ADDENDUM NO. 2 TO THE BID DOCUMENTS FOR Blankenship Road Improvements Project #PW0910 IN WEST LINN, CLACKAMAS COUNTY, OREGON CITY OF WEST LINN, OREGON

Issued: May 5, 2010 Issued by: <u>Boris Piatski, PE</u> Civil Engineer

ATTACHMENT

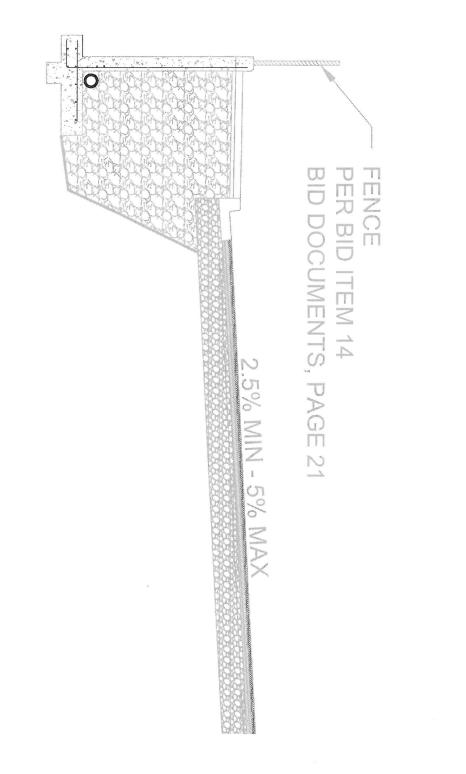
ITEM NO. 3 – SEE ATTACHMENT, showing location of the fence on the top of the retaining wall per BID ITEM 14,
